Our ref: NI2162 – Monaghan DSS Regeneration

Your ref: ABP-314501-22

South Dublin Street and Backlands Regeneration Project. The proposed development covers an area of approximately 2.72 hectares and comprises urban regeneration and public realm proposals. Properties at 7- 13 Dublin Street, lands to the rear of 1-9 The Diamond and 1-26 Dublin Street, the Courthouse car park, Lower Courthouse car park, Castle Road, and N54 Macartan (Broad) Road, townlands of Roosky and Tirkeenan, Co. Monaghan.

I refer to the above mentioned proposed development and to the Further Information (FI) request issued by An Bord Pleanála (ABP) on 13th February 2023 under the terms of section 175 of the Planning & Development Act 2000 (as amended).

Figure 3: Extract from GA drawing of proposed development plots

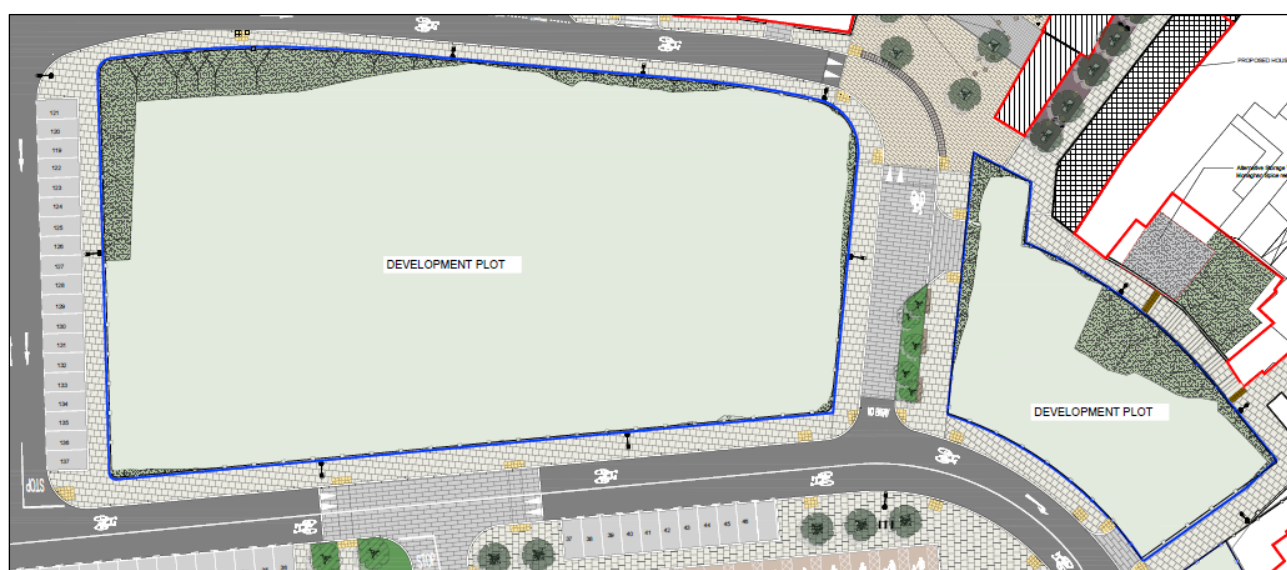
In respect of the reduction in the proposed block size or a mid-pedestrian link of the block between Church Walk and The Mall, this can be considered in the context of future planning applications for relevant developments on this plot. In that context it is envisaged that future development proposals will progress through separate planning processes, sub-dividing the overall plots into smaller development parcels with connections within the site, and with the surrounding backlands quarter and wider town centre. Appropriate uses would include retail at ground, and residential or office use at upper floor levels. This may be as a large footprint building or incremental block development, which would accommodate new mixed town centre uses and activities, so a degree of flexibility is required to attract suitable investment. This future development will would form a core part of the new façade of the Dublin Street Quarter and would be designed to integrate seamlessly into the existing urban fabric/streetscape and new network of movement routes.

The MCC regeneration objective reflects that of DSRP seeing these development plots as the focus of new urban development in the future, creating new building forms, strong blocks of modern design along the new movement routes, and with active frontages. DSRP envisaged that the scale of the sites are such that frontage development could occur facing Church Walk to the north and The Mall to the south. MCC anticipate that the development of these plots will take place incrementally as new investors/development partners are attracted to the area.

Figure 4: Extract from GA drawing showing retention of outbuilding to the rear of No.24

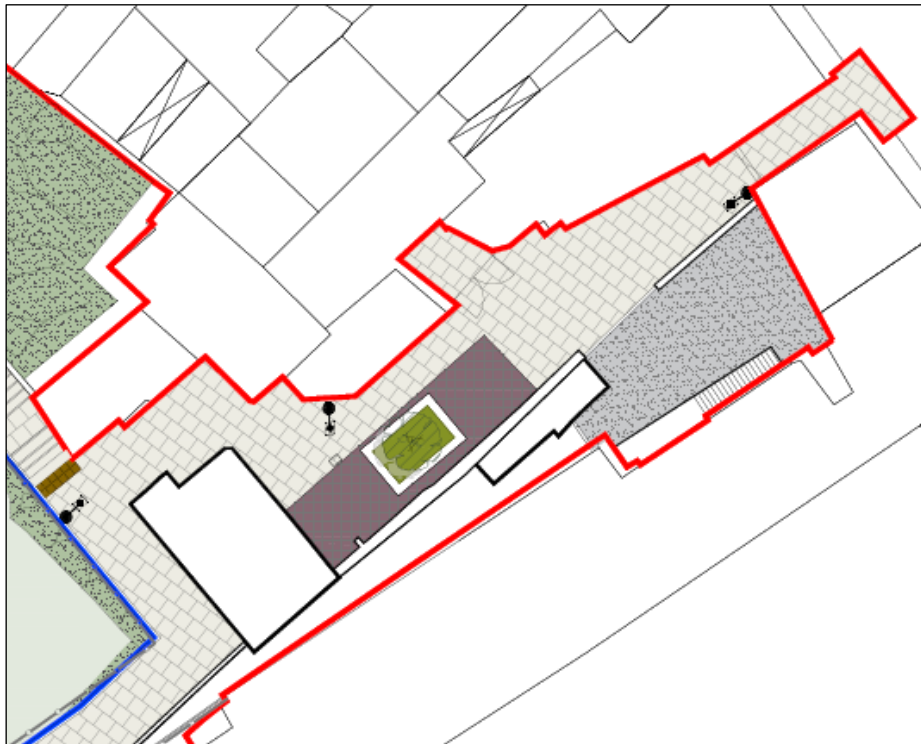
The proposed development includes for improvements to the existing alleyway connection route from Dublin Street to the rear of No 24 Dublin Street (Sherry's Pub). MCC and the Design Consultants have revised the design proposals for the area to ensure the outbuilding to the rear of No. 24 is now retained to allow the property owner to refurbish the building for alternative use in the proposed new public realm area. The property owner has secured planning permission to refurbish the outbuilding and it is hoped that they will proceed with the refurbishment once the relevant public realm upgrades proposed as part of the regeneration scheme are implemented.

Sherry's Pub is a protected structure and the revised regeneration proposals incorporating the retention of the stone outbuilding to the rear of the Pub is in line with the County Development Plan policy requirements to preserve and enhance such structures and in recognition of a current planning permission for an alternative use as retail premises.

The public realm upgrades proposed for this alleyway connection include resurfacing with silver grey natural stone paving and warm toned natural stone setts surrounding a raised planter with integrated seating, providing continuity and legibility throughout the pedestrian network. Proposed lighting columns will also attract additional footfall.

Figure 5: Extract from GA drawing showing location of proposed steps

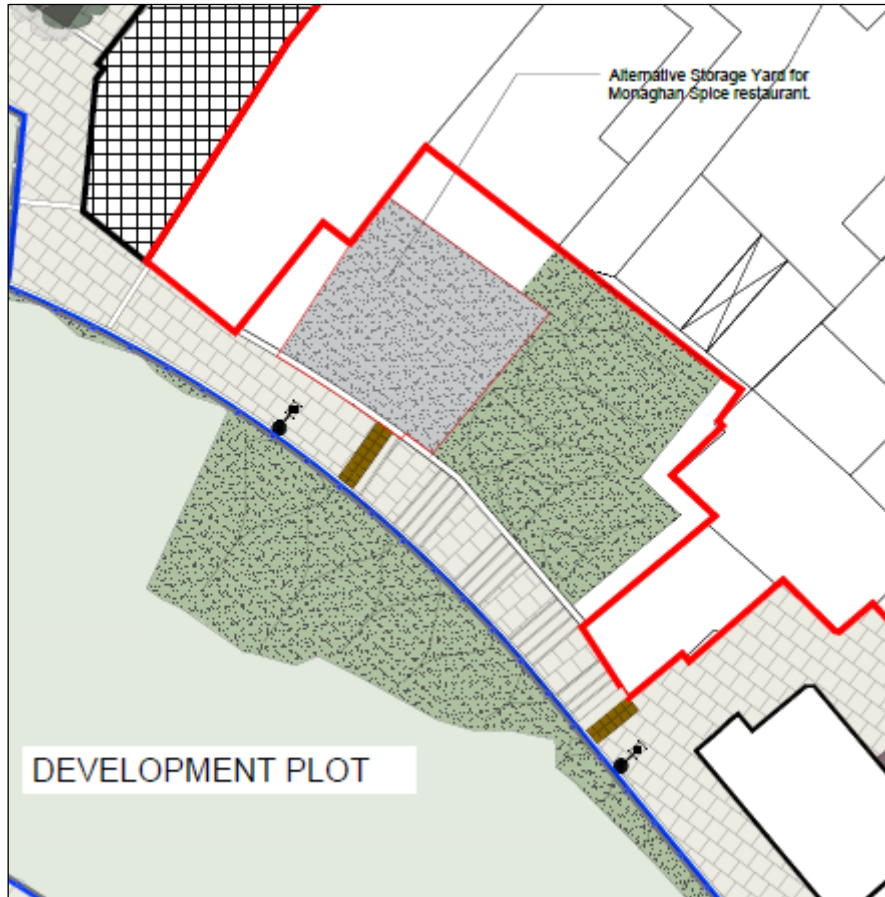
- c) **Submit a site layout plan, with additional detail indicating those areas where steps are proposed.** Response: As per the image extract below taken from the site layout plans, there are steps proposed to the northern boundary of the eastern development plot, as identified from McAdams GA drawings 231932_DSS_OP_G_100 Rev P04 and 231932_DSS_OP_G_102 Rev P04. Sections of the proposed steps have also been provided as detailed AF and AG on Construction Details drawing Sheet 4 of 4 KP1003 Rev P01.03.
